WOODLAND REVIEW FOR PLANNED REZONING OVERLAY

New Basilian Fathers Residence (SP#07-59)

Conceptual/P.R.O. Comments for Woodlands

(Rezoning 18.673)

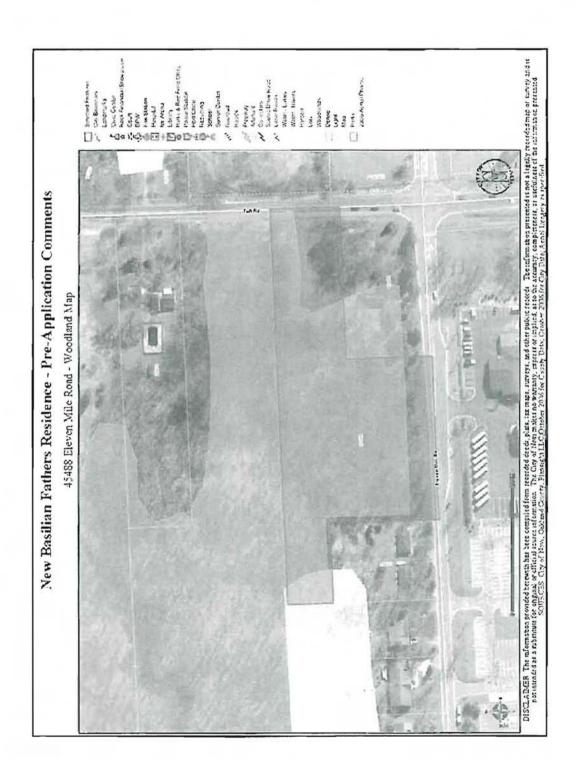
Based on our review of Novi aerial photos, Novi GIS, and the City of Novi Official Woodlands Map (attached), it appears that this site does contain Regulated Woodlands (light and medium density coverage).

As shown, there appear to be substantial impacts proposed to regulated woodlands associated with the proposed site improvements. It appears as if the proposed work (proposed buildings, proposed parking areas and access drive from Taft Road) will likely involve substantial impacts to the Regulated Woodlands located on this parcel. The plan does not currently indicate and label regulated Woodland Boundaries. In addition, the proposed Conceptual/P.R.O. Plan does not appear to be significantly different from the Pre-Application Plan that was previously reviewed by our office.

An existing tree survey has not yet been submitted. ECT recommends that we conduct a woodland field verification at the time of Preliminary Site Plan submittal in order to verify existing regulated tree locations and confirm any proposed tree replacement quantities. A tree inventory and Woodland Plan shall be provided in the Preliminary Site Plan.

Tree survey and proposed impact to any regulated woodlands trees will be addressed at the time of Preliminary Site Plan submittal. As indicated on the Conceptual Site Plan, we will attempt to minimize impacts to existing trees to the greatest extent practicable.
